Access Compliance Report

Public Rights-of-Way

(Curb Ramps)

Intersection ID: 2407	Main Street: ACACIA_RIDGE_CT	Cross Street: HIDDEN_MEADOW_LN	Location: W
ADA ID: 7F74E34B069B	Ramp Type: PerpDiag	Initial Pass/Fail: Fail	Overall Compliance: No
Severity Score: 25

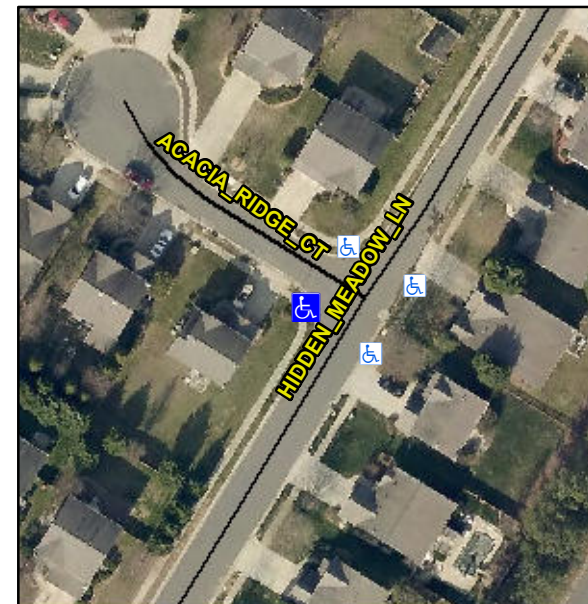
Not Found, R304.5.3

Compliance	Description	Data	Compliance	Description	Data
N/A	Ramp Length (in)	48.0	Yes	Ramp Slope (%)	5.8
Yes	Ramp Width (in)	48.0	No	Ramp XSlope (%)	12.0
N/A	Flare Type LT	N/A	N/A	Flare Type RT	N/A
N/A	Flare Slope LT (%)	N/A	N/A	Flare Slope RT (%)	N/A
N/A	Flare Traversable LT?	N/A	N/A	Flare Traversable RT?	N/A
N/A	Landing Length (in)	N/A	N/A	DWS Provided?	N/A
N/A	Landing Width (in)	N/A	N/A	DWS Contrast?	N/A
N/A	Landing Slope (%)	N/A	N/A	DWS Length (in)	N/A
N/A	Landing X Slope (%)	N/A	N/A	DWS Full Width?	N/A
N/A	Landing Curb? (Y/N)	N/A	N/A	DWS Offset (in)	N/A
N/A	Shared Landing?	N/A			
N/A	Gutter Ponding?	N/A	N/A	Gutter Slope (%)	N/A
N/A	Gutter Lip Ht (in)	N/A	N/A	Gutter X Slope (%)	N/A
N/A	Painted X Walk1?	No	N/A	Painted X Walk2?	No
	X Walk 1 Direction	To SE		X Walk 2 Direction	To NE
N/A	X Walk 1 Width (in)	N/A	N/A	X Walk 2 Width (in)	N/A
	X Walk 1 Slope (%)	6.8		X Walk 2 Slope (%)	1.5
	X Walk 1 X Slope (%)	0.3		X Walk 2 X Slope (%)	4.6

Remove & Replace Curb Ramp With Two New Directional Ramps or Equivalent.
